# SERVICE BULLETIN

No. 575

Piper Aircraft Corporation

Inspection of Horizontal Stabilizer and Vertical  
Fin Stringer Attachment Rivets

TOP VIEW OF LEFT STABILIZER SHOWN - RIGHT OPPOSITE

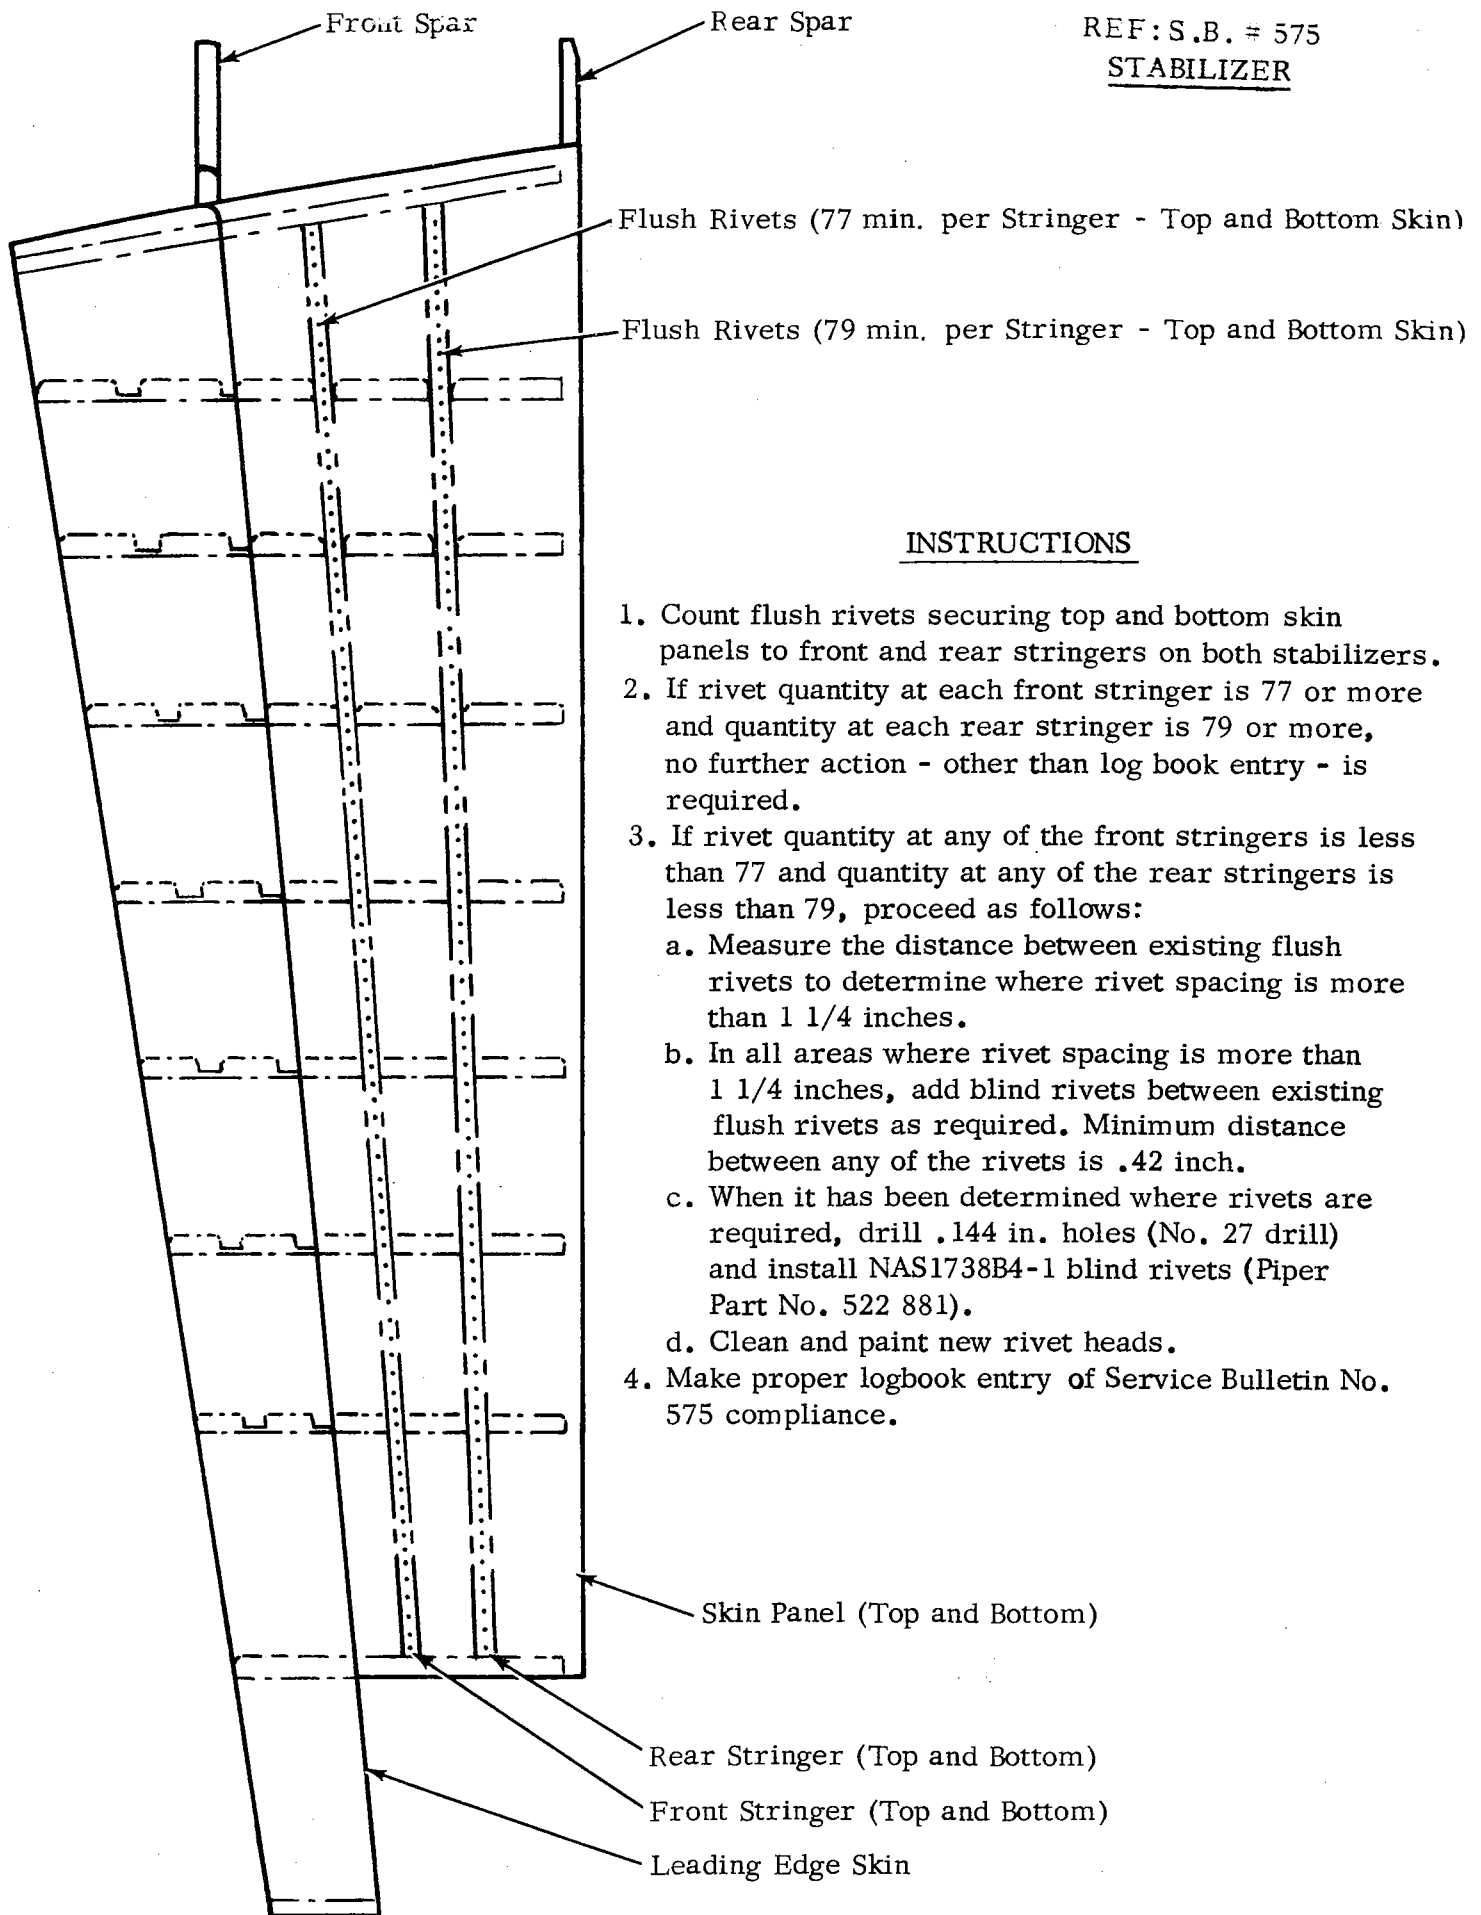
1. Count flush rivets securing top and bottom skin panels to front and rear stringers on both stabilizers.
2. If rivet quantity at each front stringer is 77 or more and quantity at each rear stringer is 79 or more, no further action - other than log book entry - is required.

3. If rivet quantity at any of the front stringers is less than 77 and quantity at any of the rear stringers is less than 79, proceed as follows:
  - a. Measure the distance between existing flush rivets to determine where rivet spacing is more than 1 1/4 inches.

- b. In all areas where rivet spacing is more than 1 1/4 inches, add blind rivets between existing flush rivets as required. Minimum distance between any of the rivets is .42 inch.

- c. When it has been determined where rivets are required, drill .144 in. holes (No. 27 drill) and install NAS1738B4-1 blind rivets (Piper Part No. 522 881).

- d. Clean and paint new rivet heads.
4. Make proper logbook entry of Service Bulletin No. 575 compliance.

REF: S. B. #575  
FIN

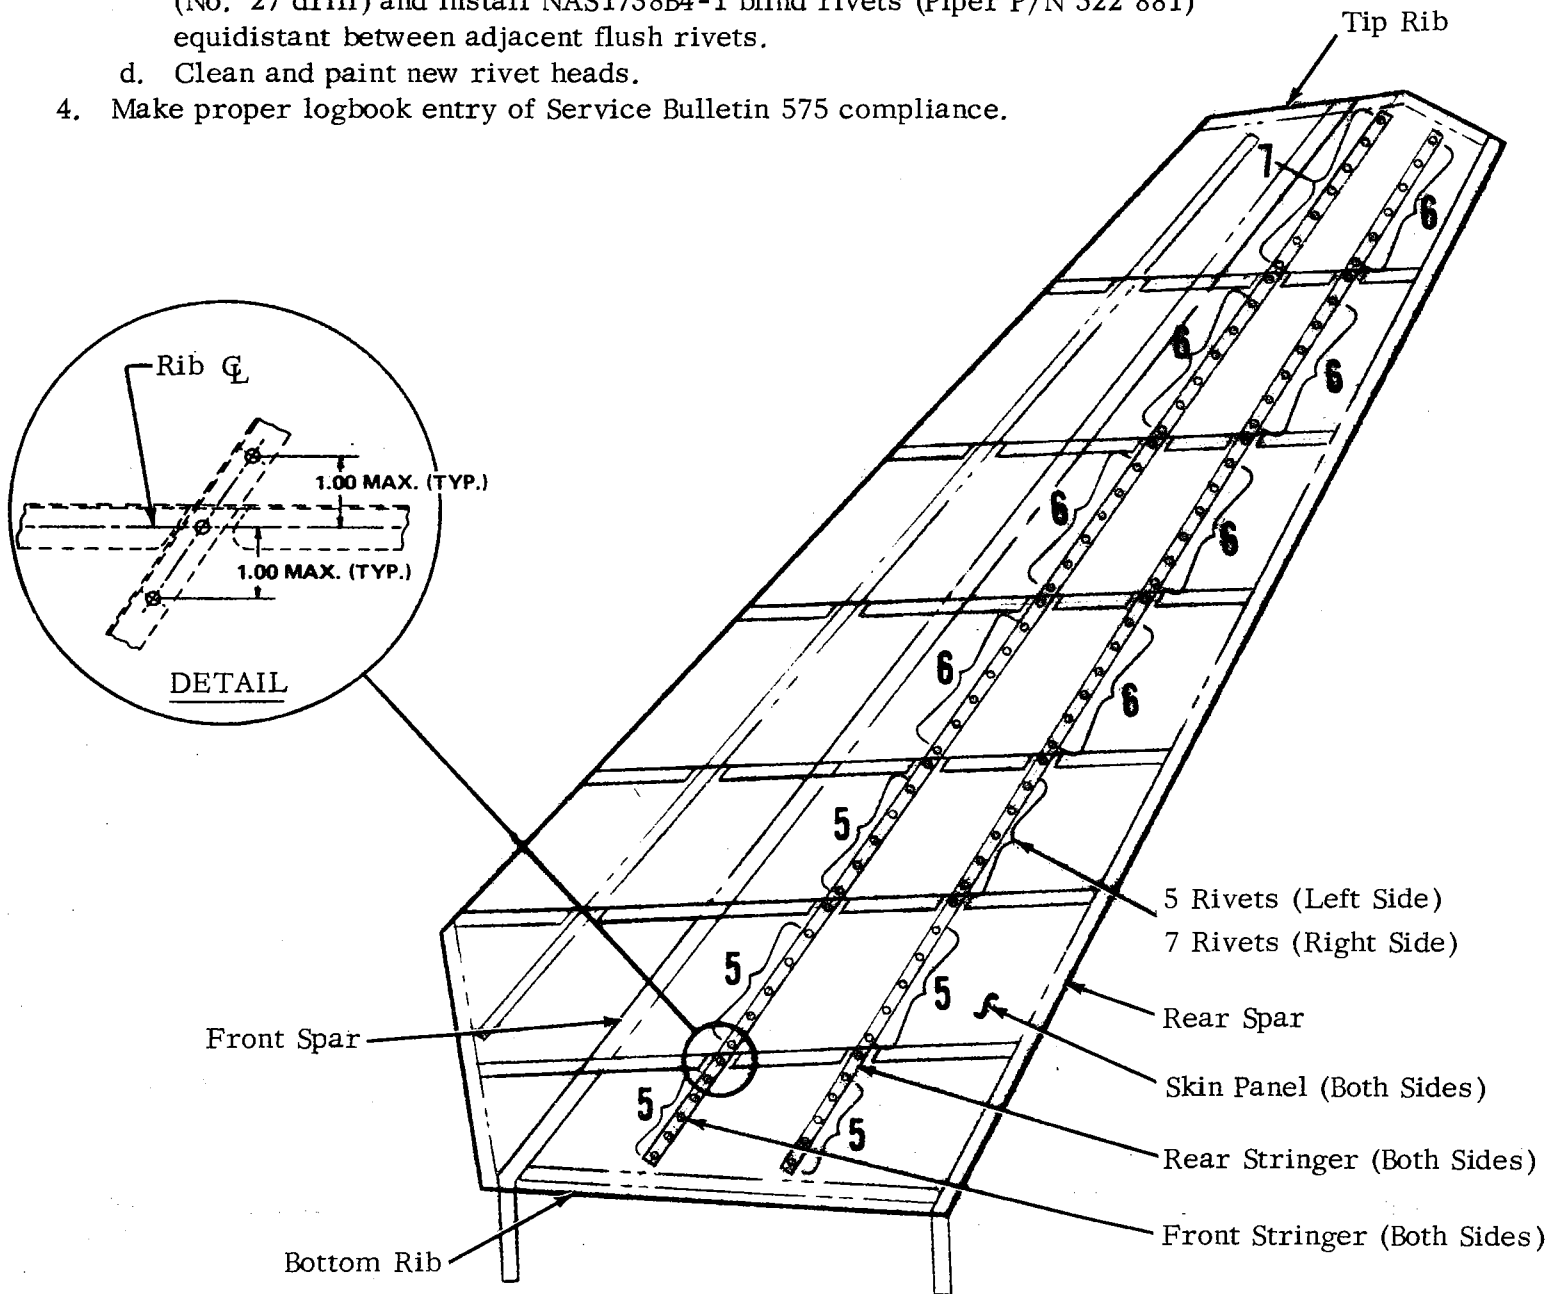
1. Count flush rivets attaching front and rear stringers to skin panels on vertical fin (both sides).
  2. If rivet quantity at front stringer is 46 or more on each side, and rivet quantity at rear stringer is 44 or more on left side and 46 or more on right side, no further action is required.

3. If count reveals less rivets than specified above on any stringer, either side, proceed as follows:
    - a. Refer to sketch for minimum number of rivets in each bay (area between ribs).  
In any bay with less than minimum number of rivets, add a NAS1738B4-1 blind rivet between each existing rivet.

- b. The first rivet above and below each rib should be spaced 1" maximum, measured from the rib centerline. See detail.  
In any area where this spacing exceeds 1", add a NAS1738B4-1 blind rivet between rib and first stringer rivet.

- c. When it has been determined where rivets are required, drill .144 holes (No. 27 drill) and install NAS1738B4-1 blind rivets (Piper P/N 522 881) equidistant between adjacent flush rivets.

- d. Clean and paint new rivet heads.
  4. Make proper logbook entry of Service Bulletin 575 compliance.
-
